Canyon Fuel
Company, LLC.
Sufco Mine

Re: Permit Modification to Abandon Groundwater Monitoring Wells 89-18-1 and 89-20-1, Canyon Fuel Company, LLC, SUFCO Mine C/041/002

Title: Abandoned Groundwater Monitoring Wells

**Water Monitoring Well
 Location Detail Map**

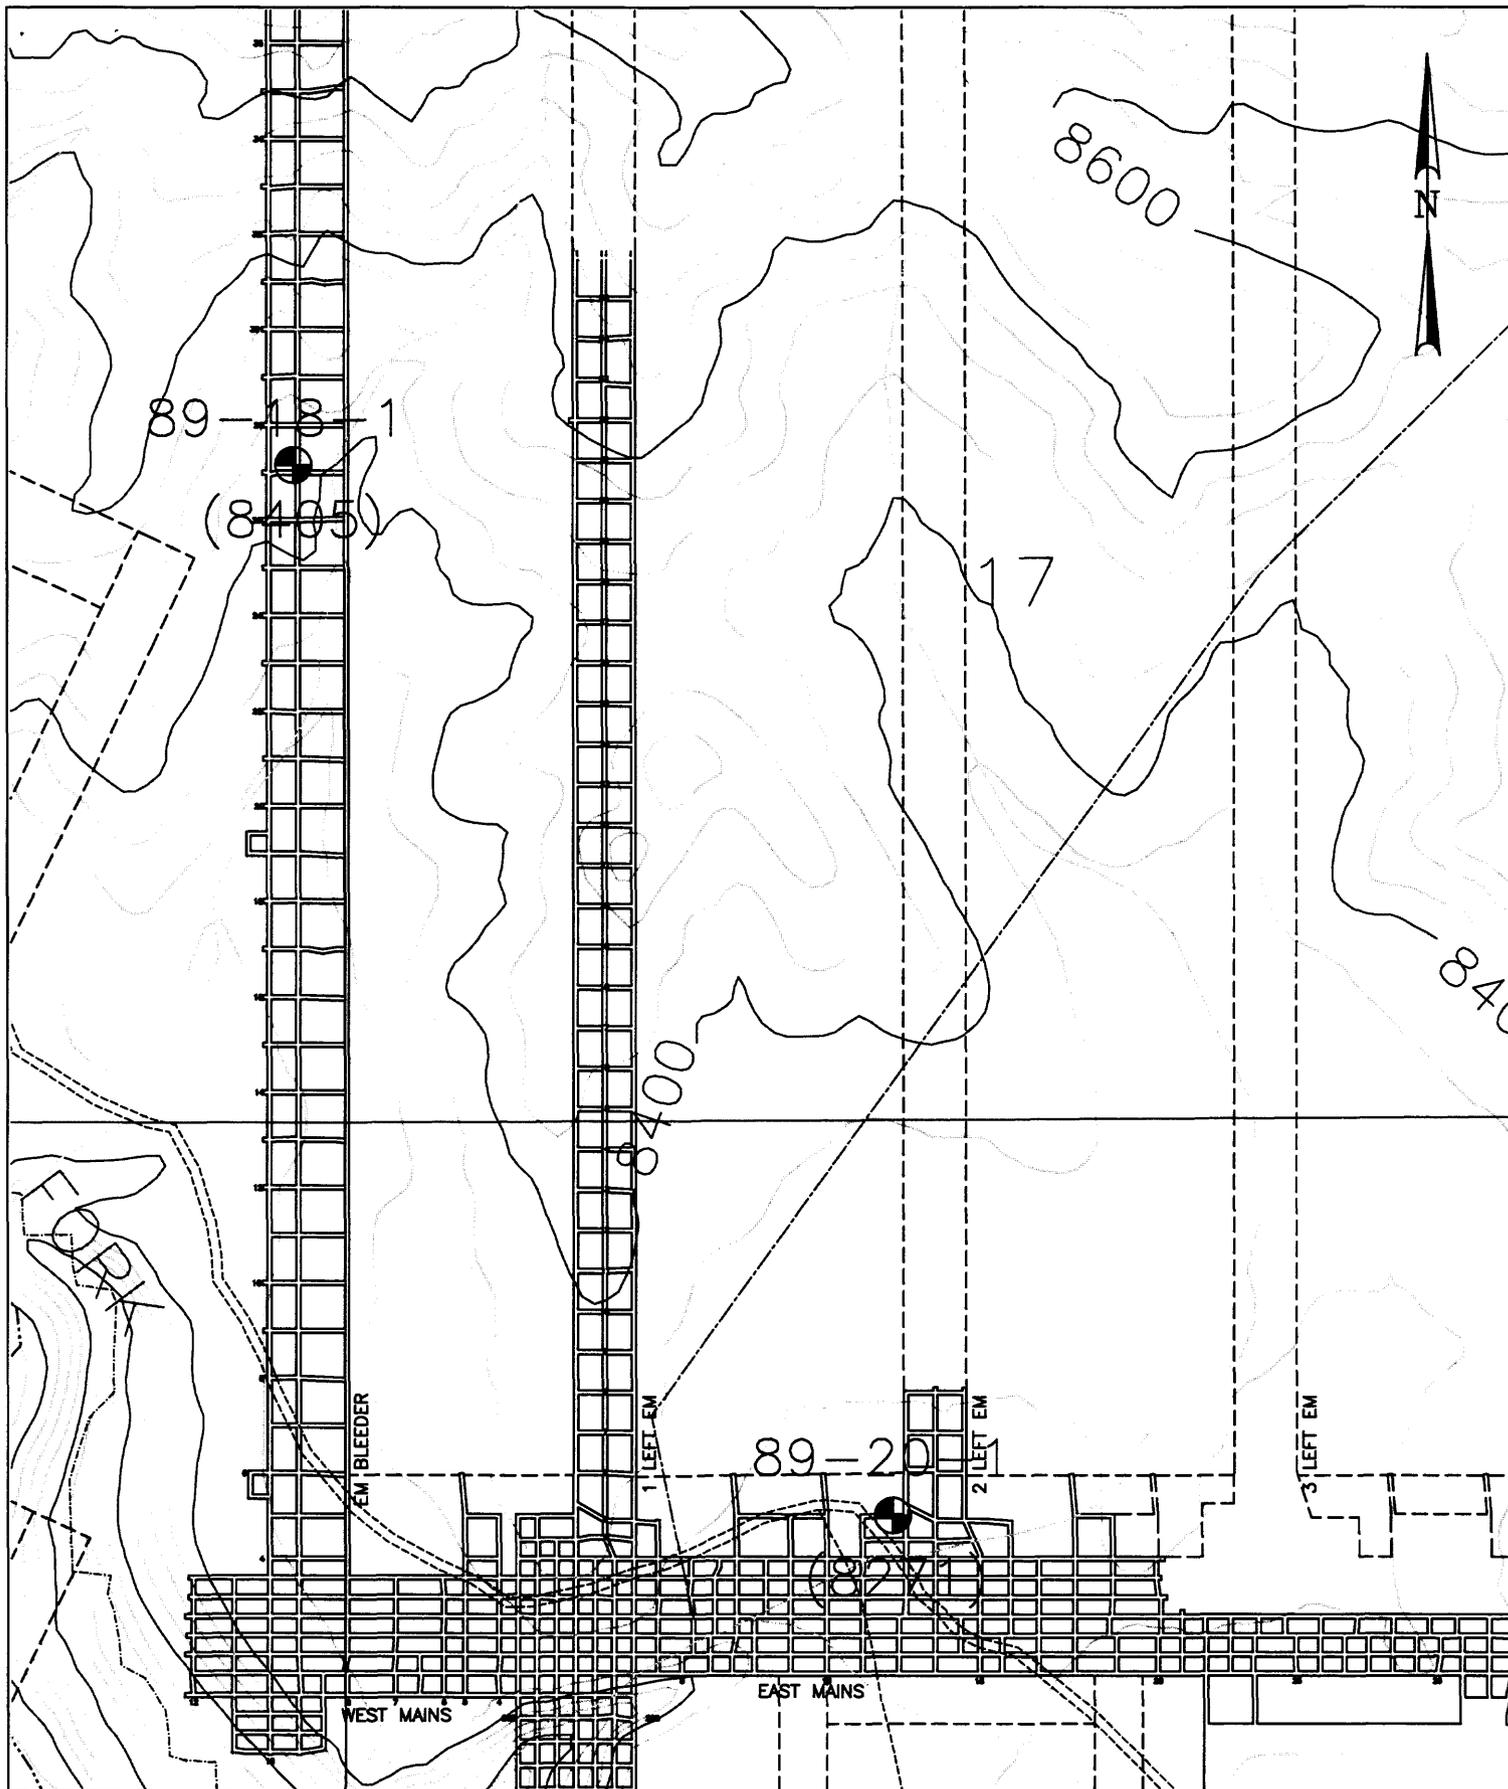
Please find enclosed with this letter eight copies of a permit modification to abandon two groundwater monitoring wells 89-18-1 and 89-20-1 because the water level measurements are no longer possible due to the collapse or blockage of the casing. This was discovered during the Sufco second quarter groundwater monitoring in June when these two wells could not be probed for the water level measurement. Sufco compared the two well locations with the mining progress maps and monitoring well 89-20-1 was mined through approximately December 5-7, 2005 in the 2 Left EM panel and well 89-18-1 was mined through approximately May 24-26, 2006 in the EM Bleeder panel which would cause the collapse or blockage of the casings (See attached location detail map or Plate 7-3).

Groundwater monitoring wells US-81-3, 89-16-1, ~~and 89-16-1W~~, 89-18-1, and 89-20-1 have been abandoned from the monitoring plan because the water level measurements are not possible due to the collapse or blockage of the casing.

Groundwater monitoring wells US-81-3, 89-16-1, 89-16-1W, 89-18-1, and 89-20-1 have been abandoned from the monitoring plan because the water level measurements are not possible due to the collapse or blockage of the casing.
